## 15.7 Radioactive Release from Subsystems and Components

The information in this section of the reference ABWR DCD, including all subsections, figures and tables, is incorporated by reference with the following departure and supplements.

STD DEP T1 2.15-1

STD DEP 11.3-1 (Figure 15.7-2)

Figure 15.7-2 Offgas System (See Subsection 11.3)

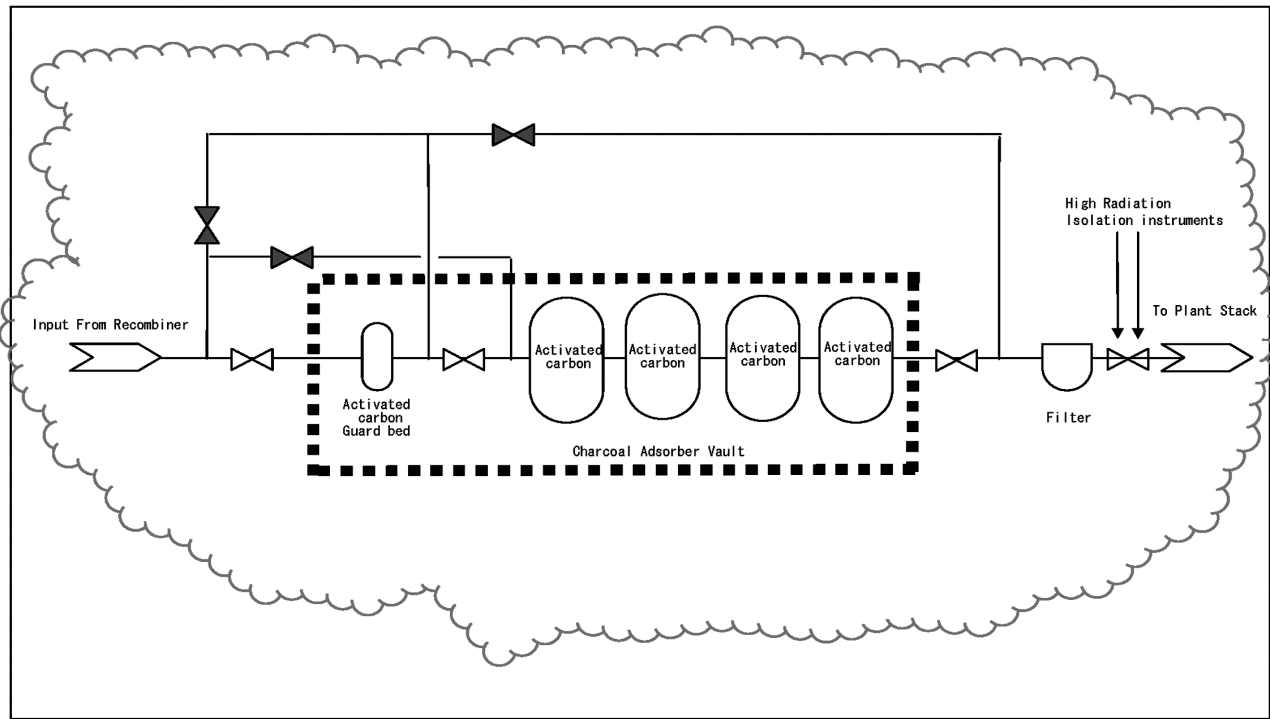
*To evaluate the potential radiological consequences of an inadvertent bypass of the charcoal beds, it was assumed that operator error or computer error has led to the bypass of the ~~eight~~four follow-on beds in addition to the failure of the automated air operated downstream isolation valve. It is also assumed that during this period, the plant is running at and continues to run at the maximum permissible offgas rate of 14.8 GBq/s (based upon the assumption of 0.0037 GBq/s/MWt as stipulated in Standard Review Plan 11.3) evaluated to a decay time of 30 minutes from the vessel exit nozzle. Even with the failure of the downstream isolation valve, it is not anticipated or assumed that the isolation instrumentation would fail but would instead*

- (1) Flow is through a single 4,721 kg charcoal tank with an evaluated hold up time given by NUREG-0016, equation 1.5.1.6 using  $K_d$ 's for Kr and Xe from NUREG-0016.
- (2) ~~An isolation valve prevents flow through the~~ ~~There is no motive force to remove any significant inventory from the eight~~ follow-on charcoal tanks while in bypass and therefore no activity from these tanks is included in the final release calculations.
